Subject ▶ Change of Urethane ring 8

For Models ▶ HR2432

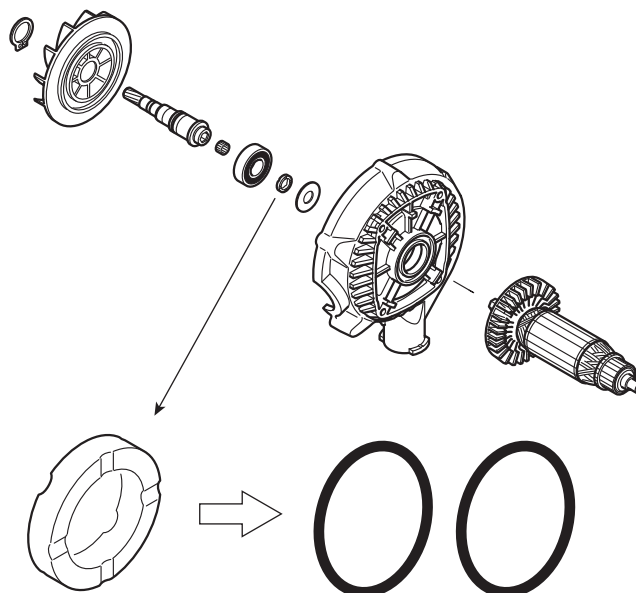
Description ▶ Urethane ring 8 has been replaced with two O rings 8 to reduce the sound level of the machine.

Item No.	Current part		Q'ty	I/C	New part		Q'ty	Note
098	Urethane ring 8		1	Yes	O ring 8		2	
	262115-3				213033-8
